Our ref: LTR-NRC-04-22

Subject: Part Response to NRC Request for Additional Information (RAI) on WCAP-15836-P, Revision 0,
"Fuel Rod Design Methods for Boiling Water Reactors – Supplement 1"
(Proprietary/Non-Proprietary)

**Partial Response to NRC
Request for Additional Information (RAI)
on WCAP-15836-P Rev. 0,
Fuel Rod Design Methods
for Boiling Water Reactors - Supplement 1**

Figure 3-1
Finite Element Mesh used by the TAMFEP Code

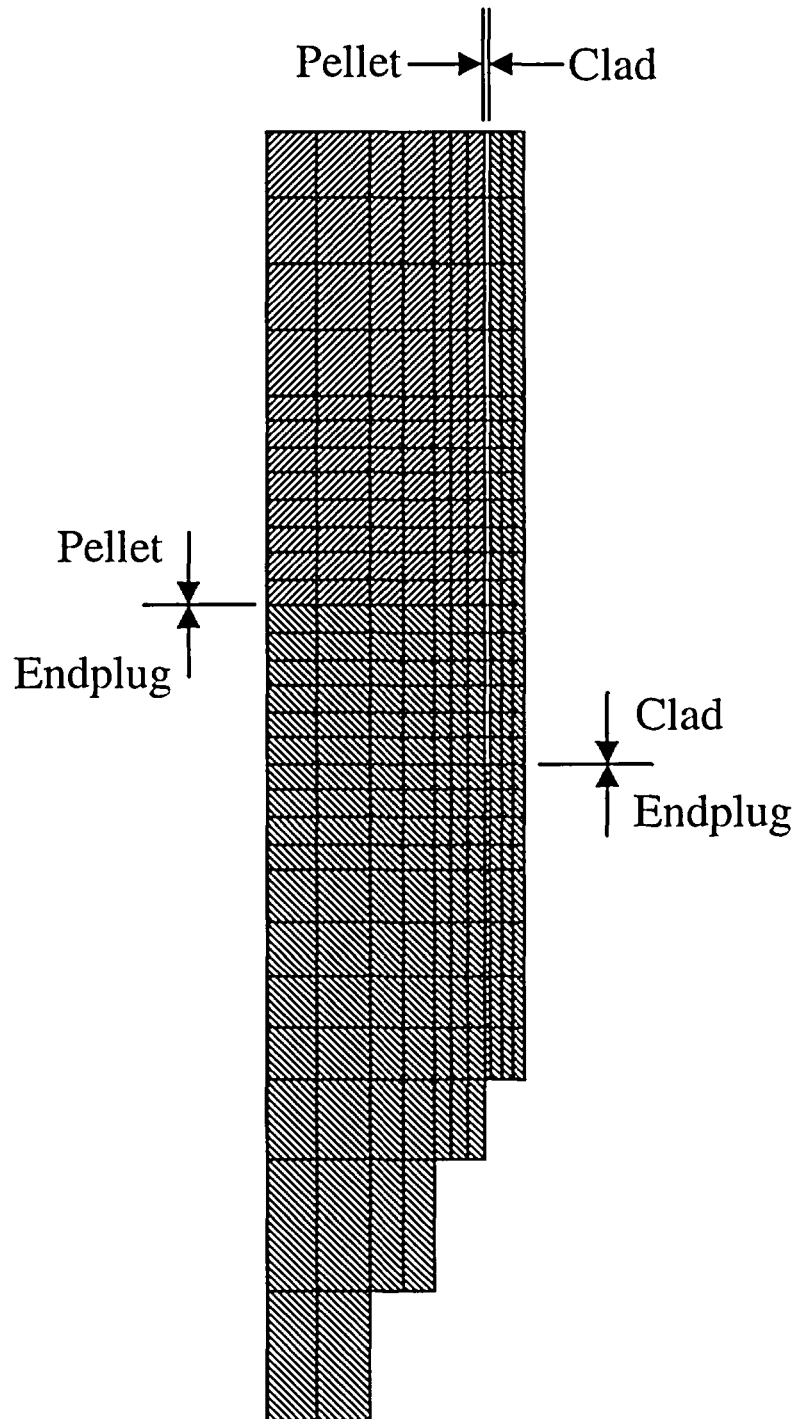
A finite element model is used to determine thermal gradients and stresses at the bottom end plug (Section 4.2.2). The accuracy of this modeling is dependent on a number of parameters (e.g., mesh and finite element type). Please provide a better description of the finite element model for the end plug. In addition, a stress concentration factor is used to derive the localized stresses at the end plug. Please provide a description of how this stress concentration factor was chosen.

A typical end-plug weld finite element mesh used by the TAMFEP code is shown in Figure 3-1 below. The same geometric mesh is used for both the thermal and stress analysis. Note that a section of the pellet stack is modeled. The mesh uses three elements across the thickness of the clad and in the area of interest at the end-plug weld the element aspect ratio is no greater than 2.5. The finite element type, used in both kinds of analyses, is an axi-symmetric 4 node rectangular element. Note that in the stress analysis both the thermal and internal rod pressure loads are considered. The material properties (thermal conductivity, Youngs modulus and Poisson ratio) are considered to be functions of temperature.

The stress concentration factor derived from an examination of stress concentration factors for an assumed discontinuity groove around the entire circumference is typically between 1.4 and 1.5.
[
